# Service Bulletin

Bulletin No. 2005-66  
CMD 2005-06

## 2.8L Sea Water Drain Plug Location

Model	Serial Number
2.8 EI	88010500 and above that use publication 90-865861041

Figure 1

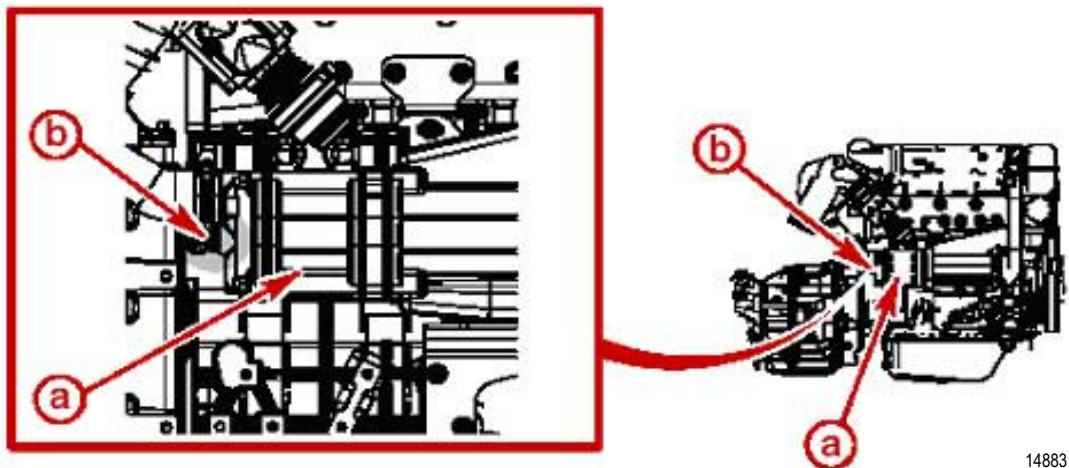
The Owners manual PN# 90-865861041 for the inboard version of the above engines has incorrect data on page 81. The call out location for the plug to drain the sea water from the heat exchanger incorrectly points to the freshwater coolant drain plug. Removing this plug will result in the loss of engine coolant.

The correct location for draining the sea water from the heat exchanger and transmission cooler is located on the rear of the transmission cooler (refer to figure 1). Owners manual PN# 90-865861041 has been updated with the correct information and is re-issued under part number 90-865861050.
